Design Note

101 Albert Street EDQ Coordination

Project Name: 101 Albert Street
Project No: 22131
Document No: RBG-DN-S-002

The purpose of this documents is to outline the fundamental characteristics of the 101 Albert Street commercial building structure and to communicate on and close out the questions raised by EDQ's independent structural engineer Arup.

Figure 4: Building Lateral Displacement in Y Direction (N-S)

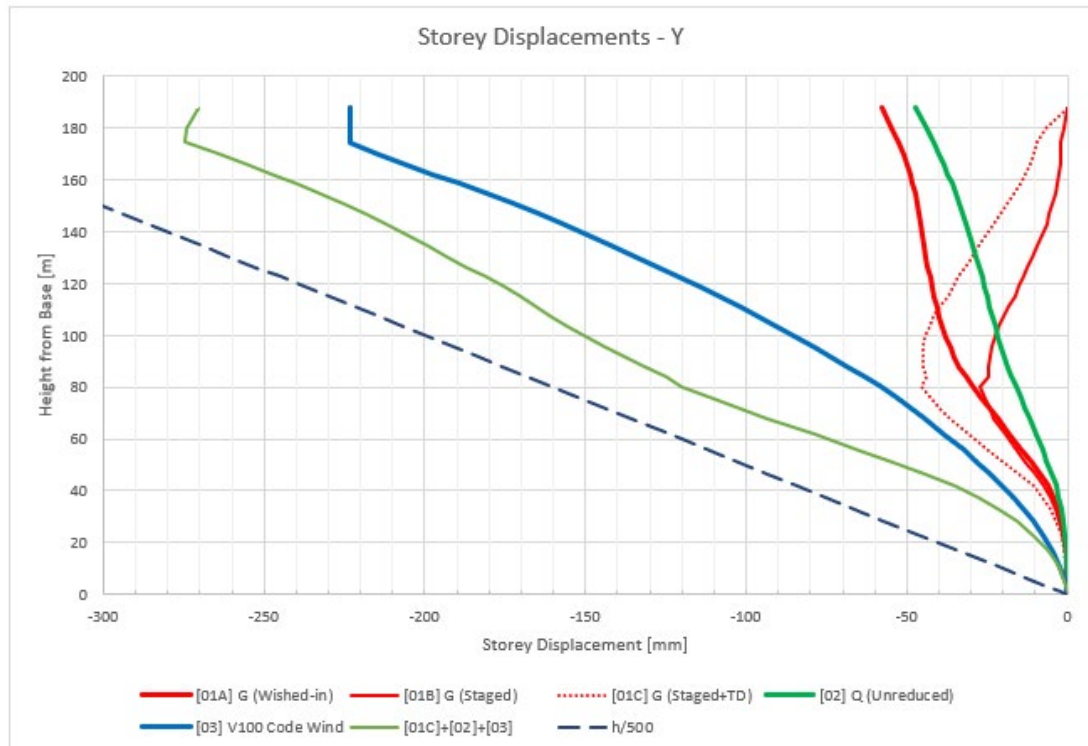
3.2 Lateral Displacements (B5.10)

Due to the side positioned core, the structure naturally tends to lean towards Albert Street under gravity loading. The elastic movement from permanent loads is also magnified by creep which increases the lean. The lateral displacement under gravity must be combined with the displacements from lateral loading (wind, seismic, robustness) when checking against the lateral deflection criteria defined for the Project.

Individual storey drifts from wind also need to be computed and compared to the $H/500$ limit as between approximately RL+40 and RL+80 the slope of the combined deflection line is greater than the limit line. It's worth noting however the following conservative aspects of these plots:

1. Basic floor by floor construction sequencing adopted.
2. SDL applied at the time as self-weight, while in reality it will be applied significantly later.
3. The total live load is included in the combined deflection without a combination factor or live load reduction.
4. Wind displacements are based on code calculations. Assessment of the preliminary loads provided by the wind consultant indicate the actual loads are approximately 10% lower.
5. Wind displacements are also based on V100 wind speeds but could be reduced to V50.
6. Core stiffness has been reduced by 30% despite stress plots indicating very little cracking even at foundation level as discussed in Section 3.3.

The maximum inter-storey drift based on combination 01C+02+Wind Y at V50, between RL+40 and RL+80 is approximately $h/470$. Approximately 50% of this drift is due to the dead load of which a component will occur prior to façade install. With refined modelling of the items outlined above and wind tunnel loads it is expected this inter-storey drift will comply with the lateral deflection limit of $h/500$.

Figure 5: Core Wall Stress 0.9G+WU (Blue >1.0MPa, Magenta <1.0MPa)

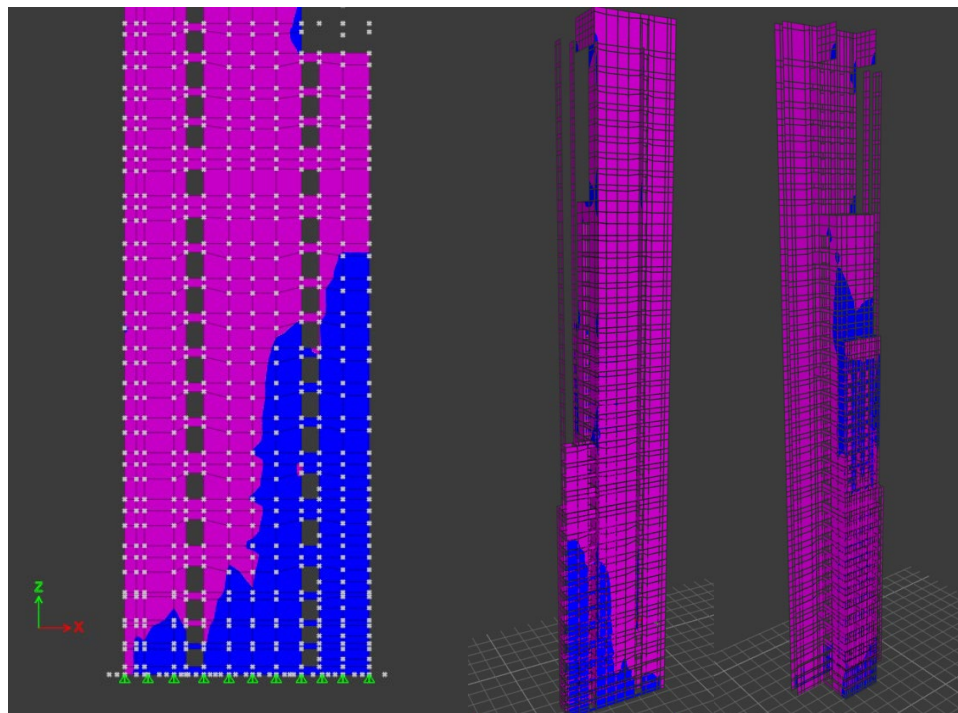
3.3 Rear Core Wall Performance (BA.3)

In a side core building the rear wall of the core, or the wall that is displaced closer to the boundary, inevitably supports less gravity load than that of the internal walls. To the contrary there is little to no change in the tension forces under lateral loading (i.e. wind, seismic,

robustness) between the rear and internal walls and the net effect is that there is typically a large tension force that needs to be considered by the rear wall at ultimate limit states. There may also be high tension stresses at serviceability level loads resulting in cracking, softening of the core and magnified lateral displacements of the structure.

To offset some of the impact of the side core extensive coordination was undertaken to achieve a “T” shape core arrangement with the larger flange located to the rear of the core which compliments the material strengths of concrete and steel. Additionally, the rear stair core module is cantilevered off the rear of the core to minimise unbalanced gravity loading and to reduce the tension forces in the rear wall. The rear wall was although thickened to 600mm to reduce the vertical stress (but not force).

Conservatively taking the concrete tensile stress limit before cracking in the rear wall as $0.36 \cdot \sqrt{50} \approx 2.5 \text{MPa}$, the rear wall concrete tension capacity before cracking is approximately 1,500kN/m. Figure 5 and Figure 6 summarise the core wall stresses based on the current state of modelling, and indicate that while tension stresses do prevail, they are within a reasonable range and will not significantly reduce the stiffness of the core. These plots are based on ultimate loading and under service level loads there is little to no tension behind the core beyond the concrete capacity before cracking.

Figure 7: Typical Mid-rise Commercial Floor Response Factor Plot

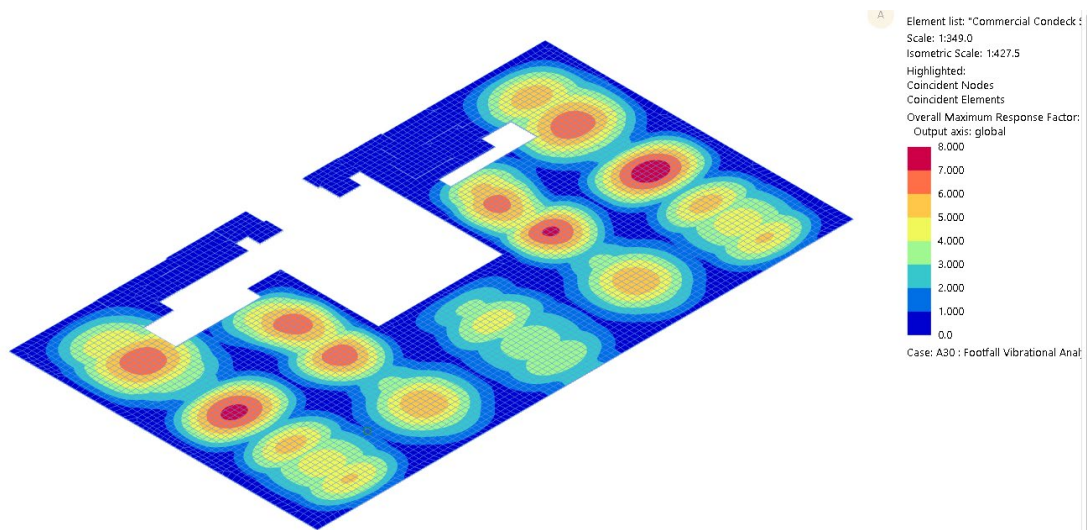
3.4 Floor Vibrations (BA.9) (Work in Progress)

RBG are currently in the process of developing the typical Mid-rise commercial floor footfall vibration model using OASYS GSA to assess the response of the typical office levels. The criteria for these levels defined in the Structural Design Criteria Report is RF8. The initial results from the analysis are shown below with the peak response factor of 7.70 noting these preliminary results need to be verified.

Figure 8: Core Shear in X Direction (E-W)

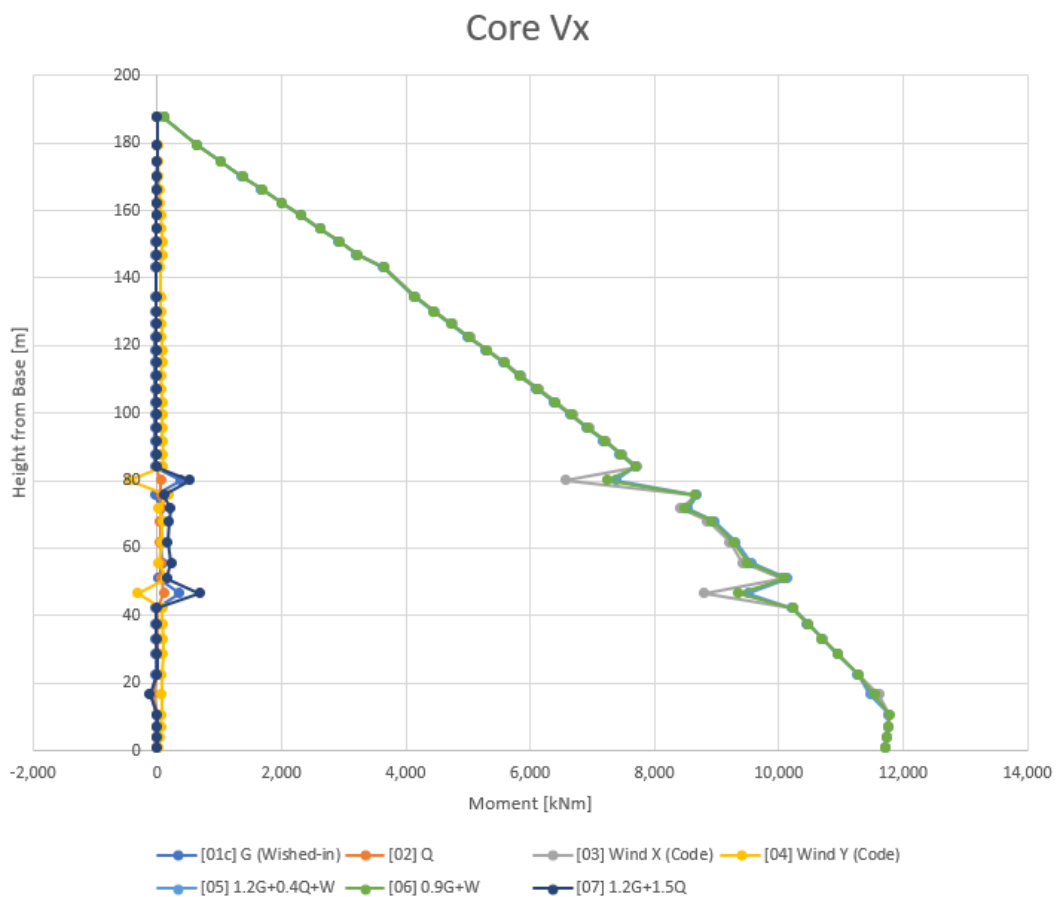
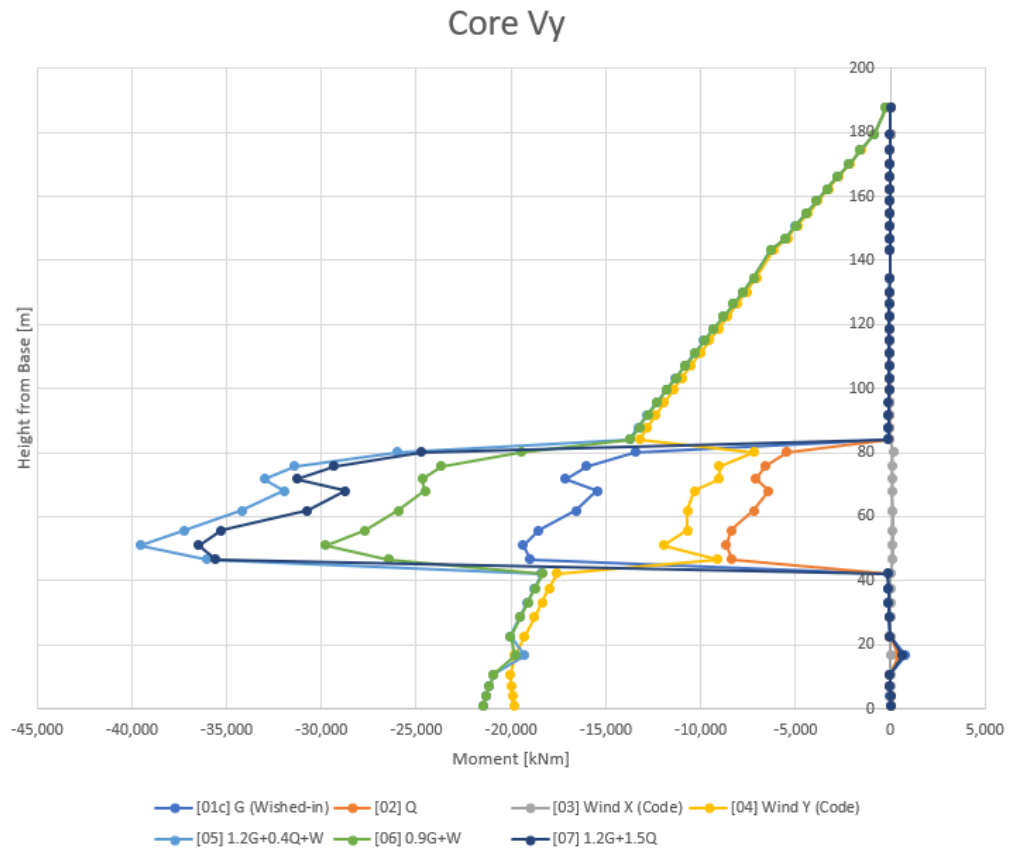
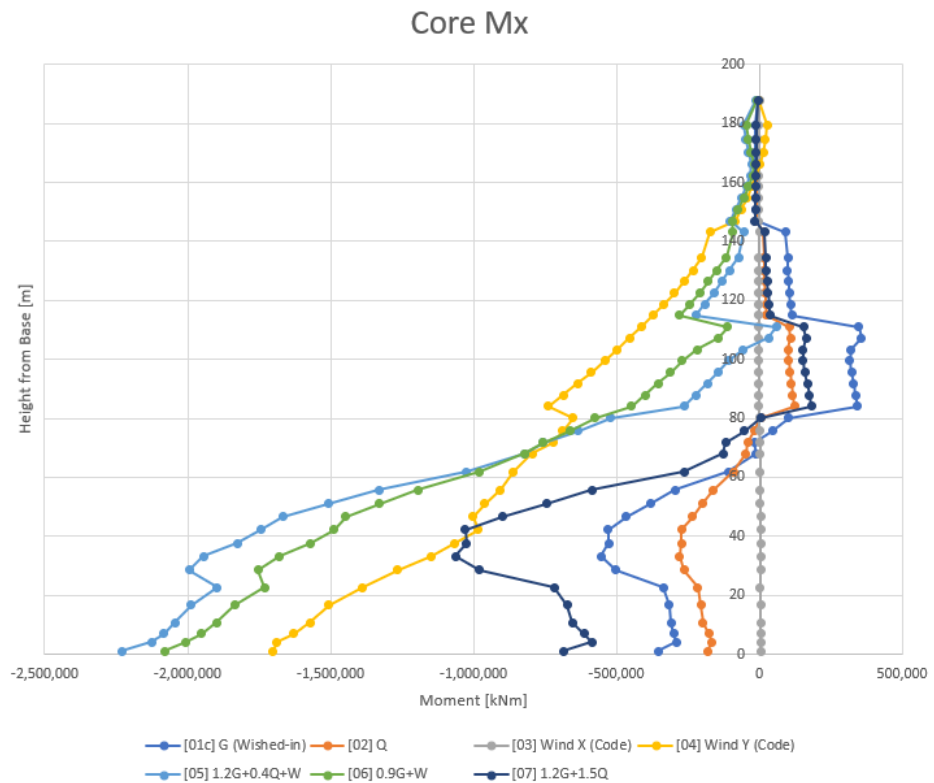
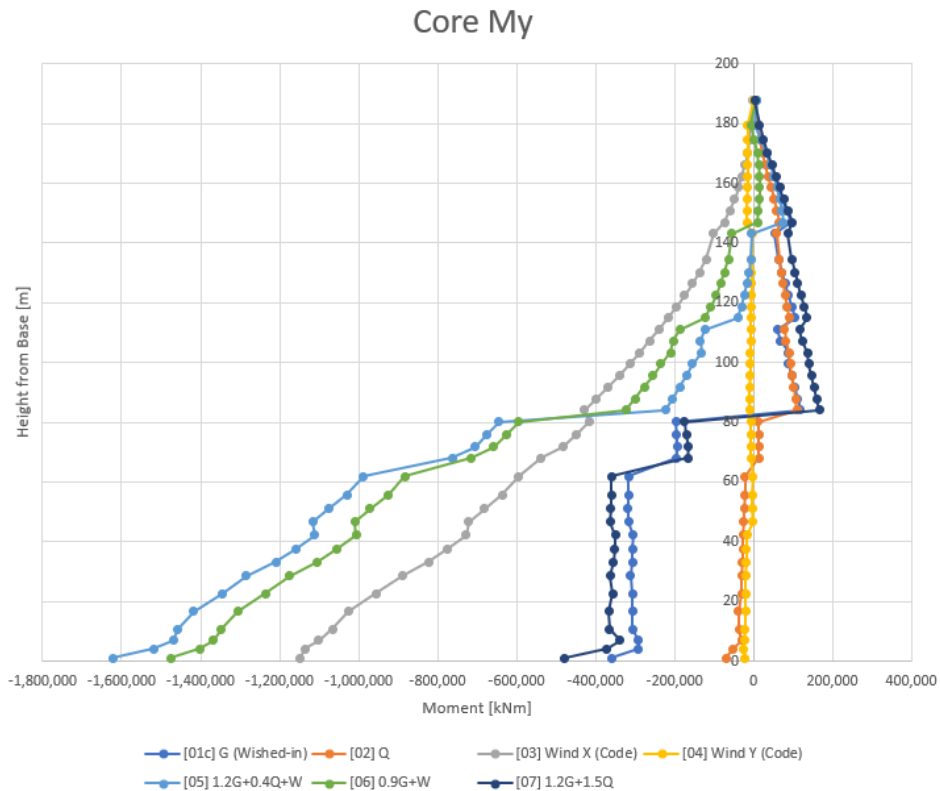
3.5 Wall Forces/Stresses (BA.10)

Figure 8 to Figure 11 summarise the key core actions based on the current state of the lateral model. The disturbances seen in the shear plots between 40m and 80m above base are a result of the raking columns and the diaphragm levels. The sudden increment in shear approximately represents the total in-plane force to be resisted by the diaphragm at each level. In the 'X' direction (parallel to Albert Street) these forces are benign. In the 'Y' direction (perpendicular to Albert Street) there is approximately 20MN from G and 10MN from Q generated in the core. In the same direction there is a net loss in wind shear from the core over the raking column extent, indicating the raking columns will be participating in the lateral system and supporting wind load between the diaphragm levels.

The jumps in magnitude seen in the moment diagrams are a result of the various core modules dropping away up the tower. This causes the pier centroid to suddenly move a large distance while the net centre of vertical load remains relatively unchanged.

Figure 12: EDG Pile Stiffness Assessment from B01493-1AL report

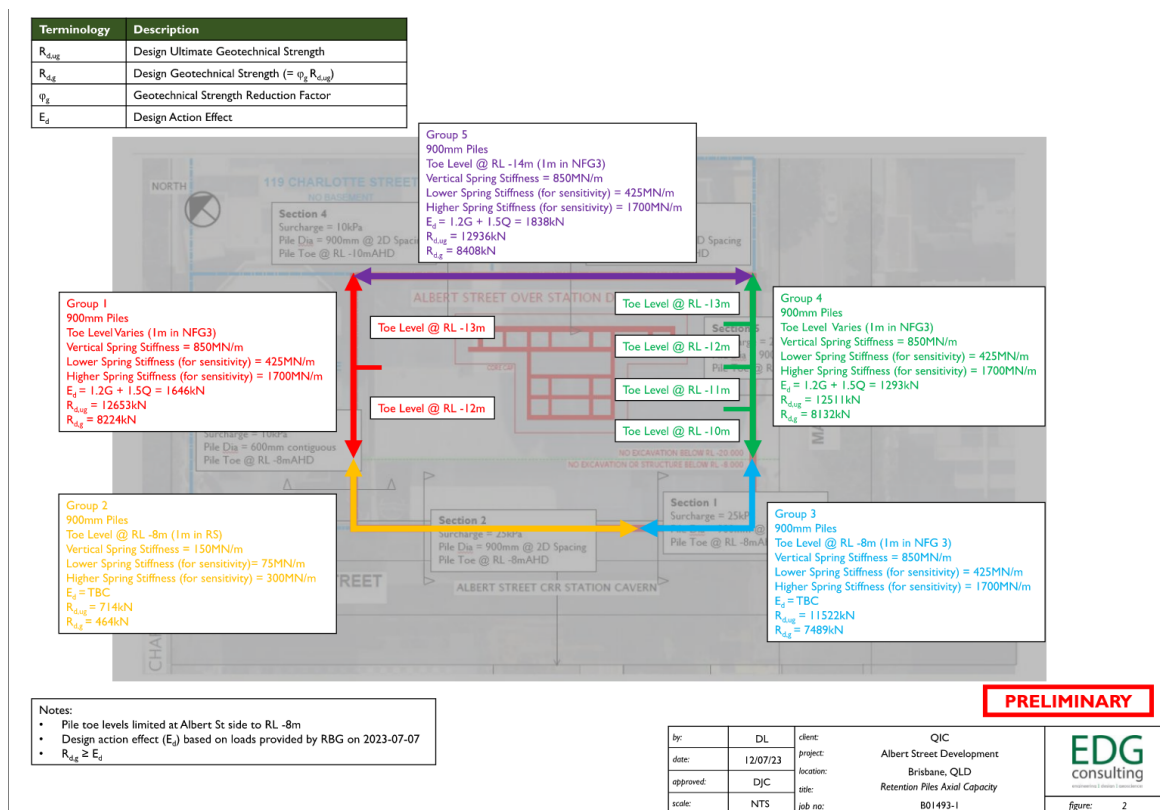
3.6 Basement Shoring and Retention Wall (BA.11)

The shoring and retention walls typically extend through alluvium and residual soils with soldier piles typically socketing into residual soil or low strength rock and the infill shotcrete panels terminating in residual soil. Based on this condition EDG estimated a first pass shoring pile stiffness of approximately 200-300MN/m and 250MN/m was adopted in the lateral model for all shoring wall piles. Shoring walls were assumed uncracked, i.e. 100% in-plane stiffness with no consideration of articulation from joints. Revised vertical and lateral loads for core piles and the new shoring piles were then extracted and provided back to EDG for use in the Cavern Assessment Model. From this EDG provided updated Analysis Group 1 results as summarised in the EDG Cavern Assessment Update attached in [Appendix B](#). Results from the revised analysis show the latest change in vertical and horizontal cavern liner displacements and change in cavern liner normal stresses to be less than the initial results. Other model refinements (e.g. wind tunnel results, storey heights, diaphragm levels) will also have contributed to this.

From this first iteration of the Cavern Assessment including shoring walls, EDG calculated more accurate vertical springs for the bases of the piles – summarised in Figure 12. The lateral model was updated to align and the latest shoring wall loads for Group 2 and 3 are presented in Figure 13 tables. Given the proximity of Group 2 and 3 to the Cavern this load check iteration has been limited to Group 2 and 3 shoring walls at this time. Overall these loads are similar the assessment performed by EDG based on 250MN/m springs everywhere and so the outcome of the Cavern Assessment isn't expected to change. As the project develops and the lateral model is updated to reflect design development, the Cavern Assessment will be performed again to ensure the project remains within the outlined performance criteria.
